Final Value Analysis Study Report

Davis Road Bridge Replacement

February 2017

Subject: Final VA Study Report (Task Order 238)
Davis Road Bridge Replacement Project

Replace first 3 spans at each end of bridge with flat slab deck on precast pile bents with precast girder main spans

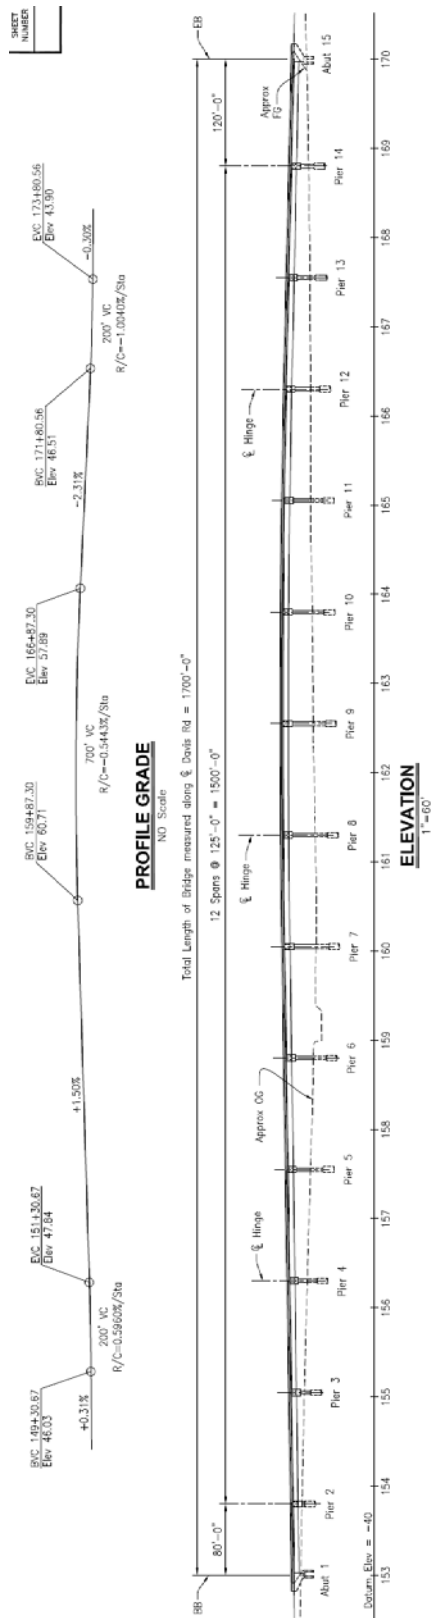
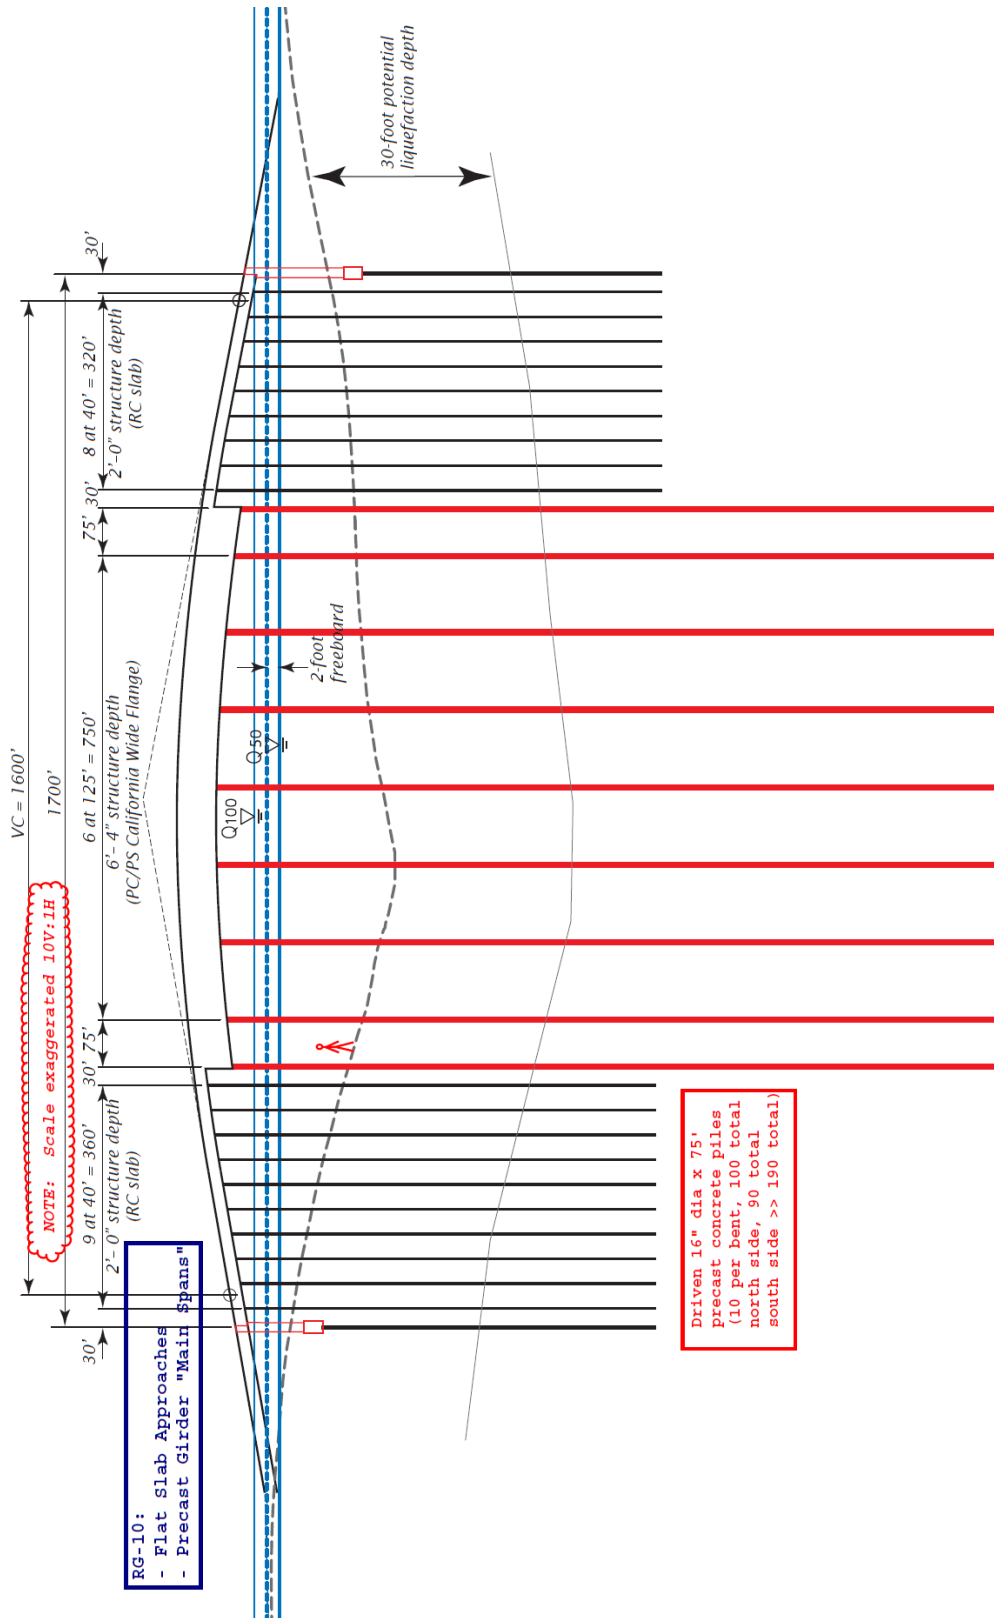
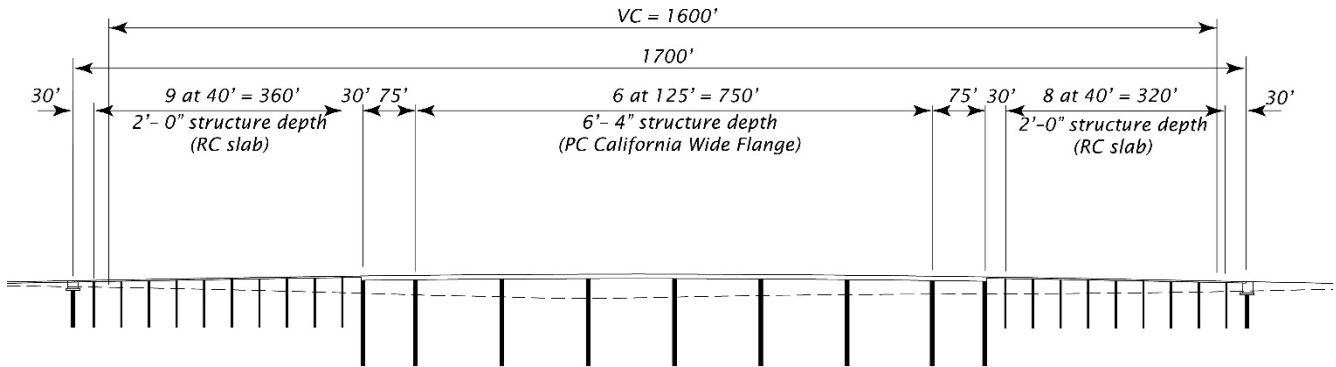
Replace first 3 spans at each end of bridge with flat slab deck on precast pile bents with precast girder main spans

Reduce median width on bridge

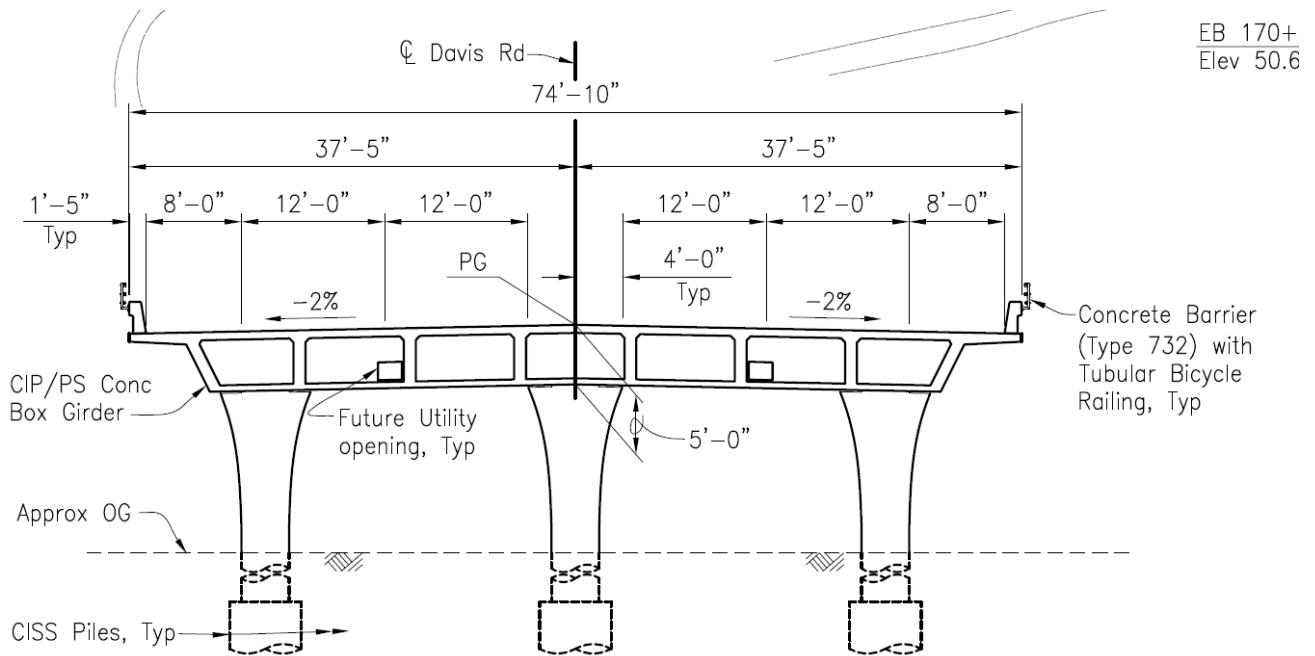
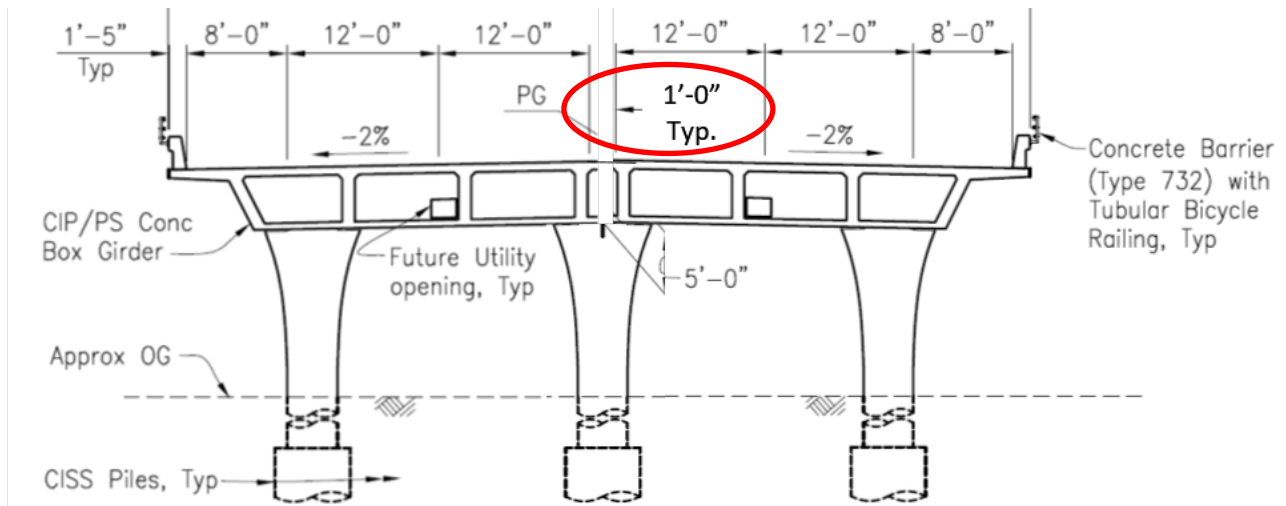
5.1b Reduce median width on bridge	\$3,130,000	No change	+1 %
The alternative concept proposes a 1 ft. wide median with rumble strips on the bridge. This concept reduces material cost, maintenance, and right-of-way farmland impacts. The baseline's 8 ft. shoulders as Class II bike lanes remain in this concept.

Reduce width of travel lanes on bridge to 11 ft.

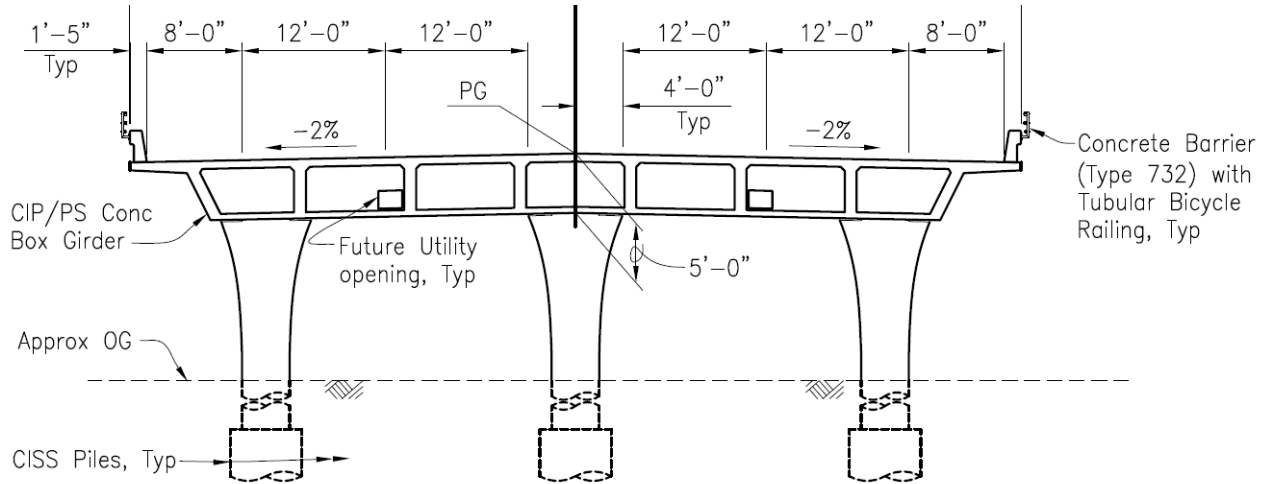
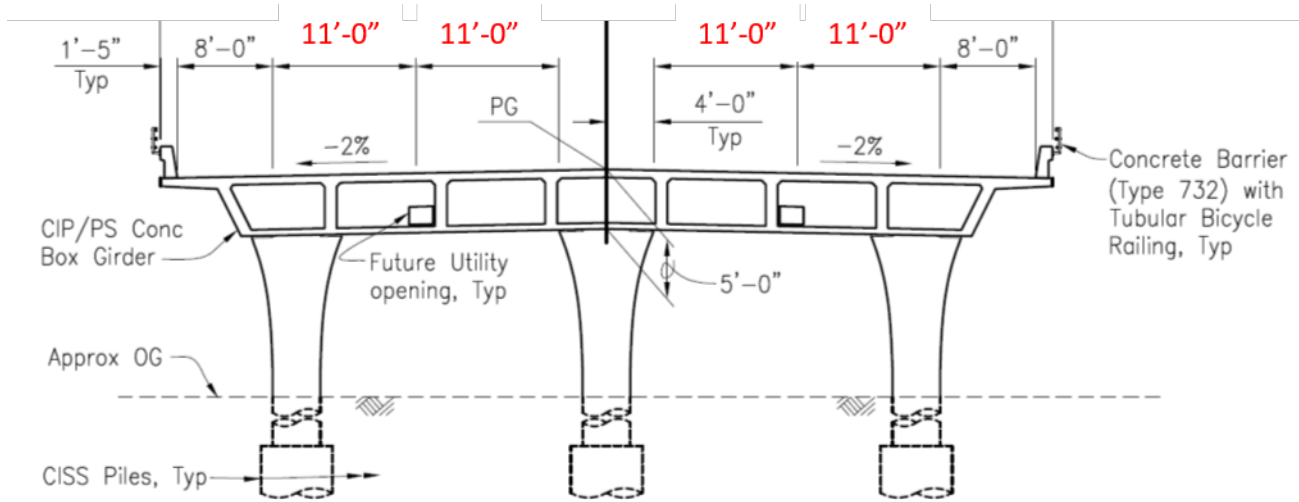
Assumptions and Calculations: 1,700' x 4' = 6,800 SF of bridge area reduction.

VA ALTERNATIVE 5.2a

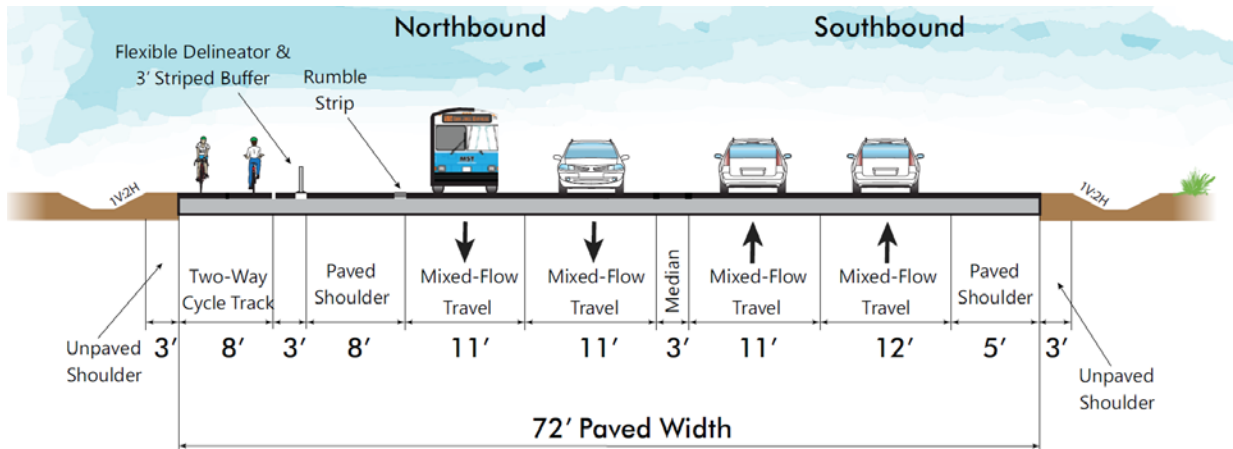
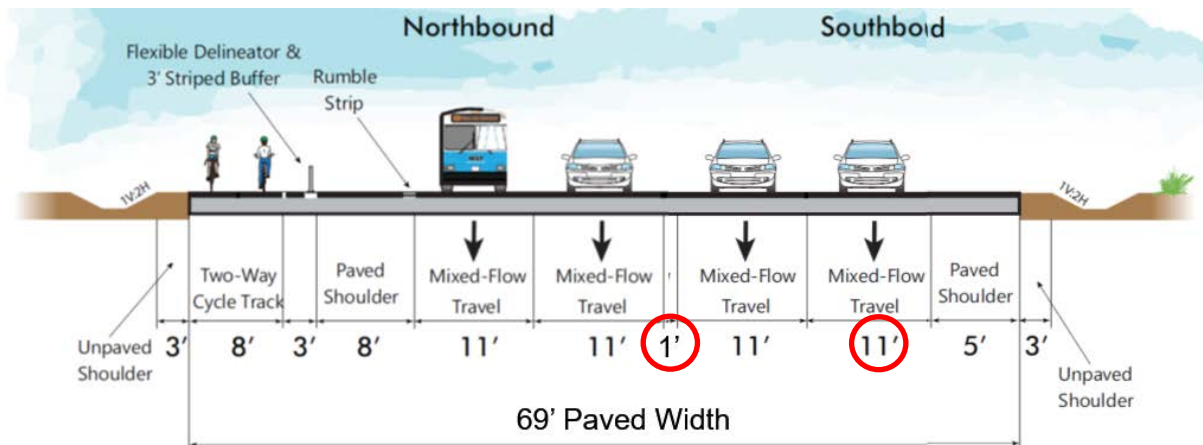
- V.A. Alternative 5.2a proposes the use of an 8' wide two-way cycle track with a 3' unpaved shoulder and a 3' striped buffer, separated from vehicular traffic by flexible delineators, per the attached typical section FIGURE 1.
- V.A. Alternative 5.2b proposes the use of a narrower 1' wide buffer separating a two-way cycle track, per the attached typical section FIGURE 2.

Engineering / Traffic Analysis: Although V.A. Alternative 5.2a does adhere to FHWA and Caltrans DIB 89 guidelines for separation (see attached FIGURE 3, DIB 89 Figure 3.0), it would not provide the same level of comfort and safety for bicyclists as would the option of separating vehicular traffic with a concrete barrier.

The true cost of Alternative 5.2a, using a concrete barrier, is \$1,140,000 over the baseline per the cost estimate in Attachment 1. If a flexible barrier is used in lieu of the concrete barrier, the calculated cost is \$290,000 over the baseline, per the cost estimate in Attachment 2. Again, however, the use of delineators is not recommended nor warranted in this scenario.

Modify frontage road and reduce length

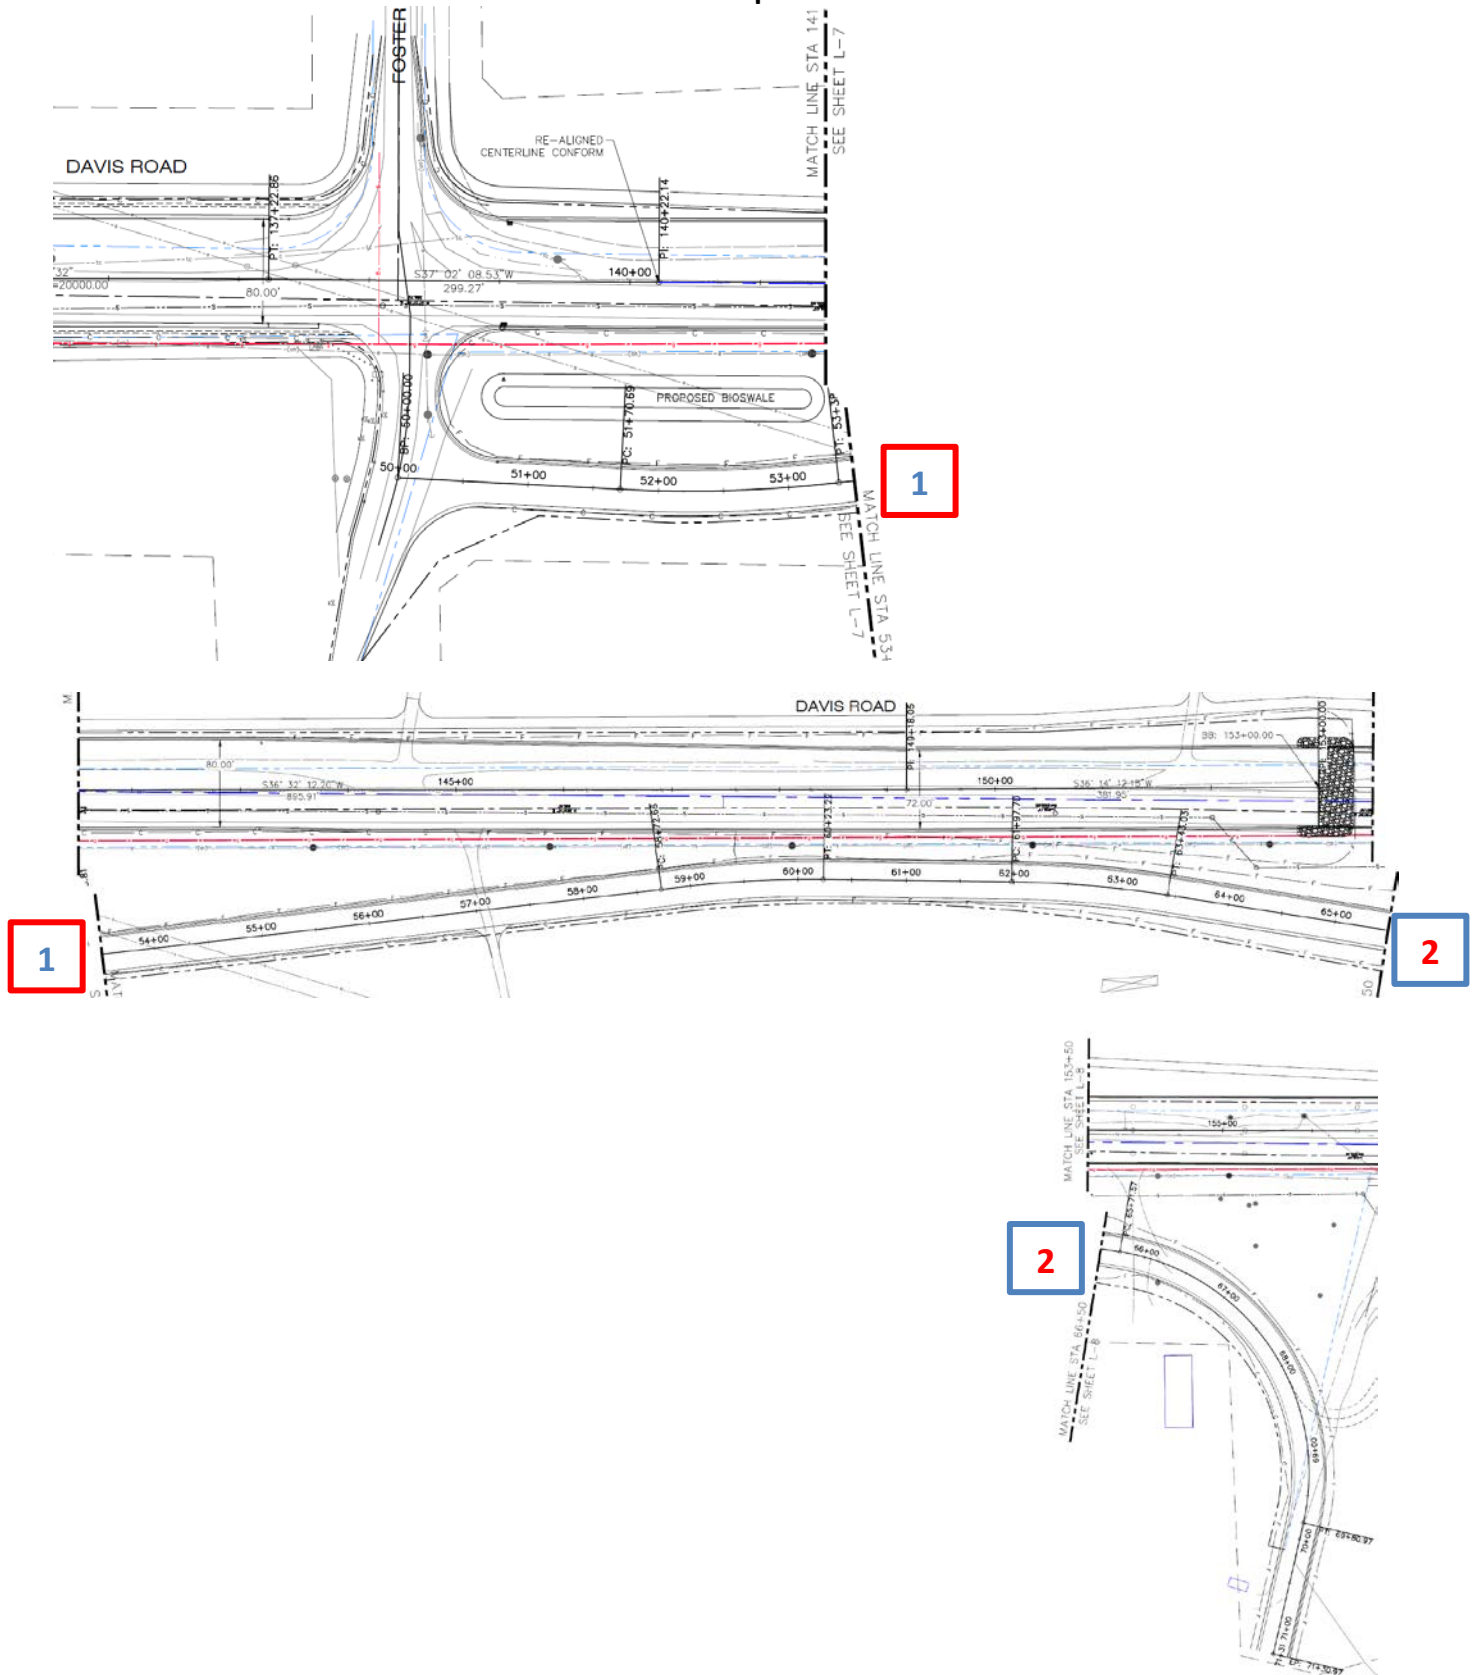
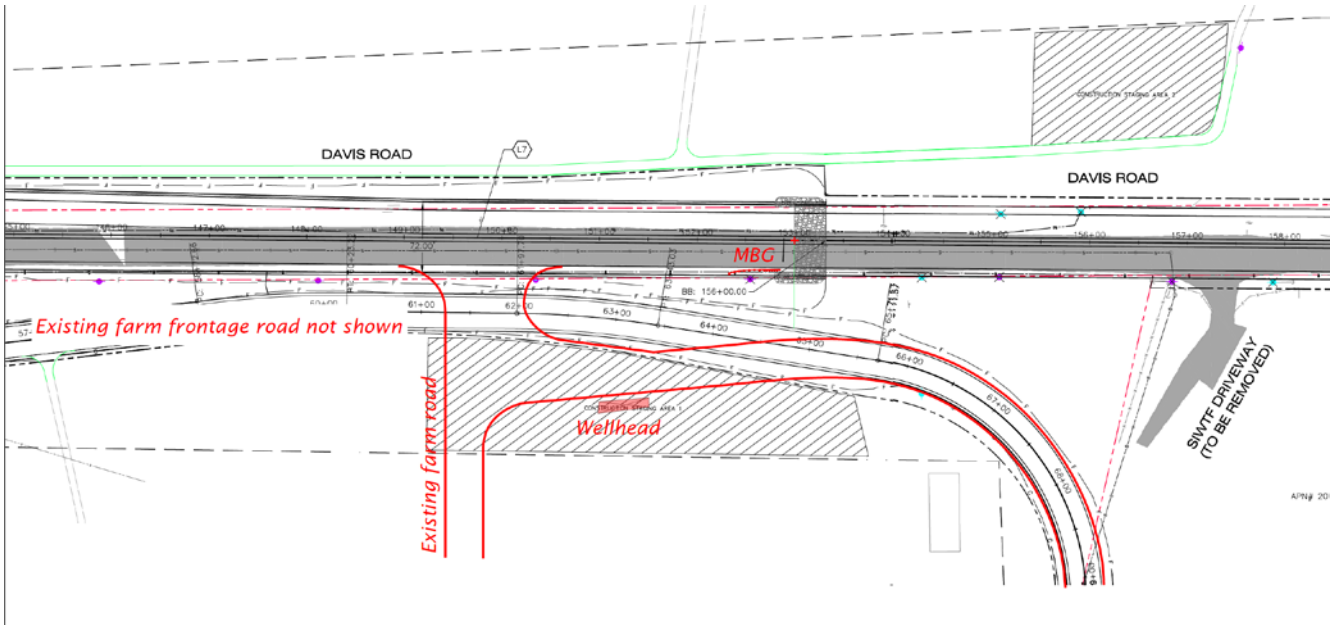
5.2b Adopt Class IV bikeway cross-section and modify buffer between shoulder and two-way cycle track	(\$1,140,000)*	No change	-1 %	-2 %
6.0 Modify frontage road and reduce length	\$1,270,000	No change	+1 %	+3 %
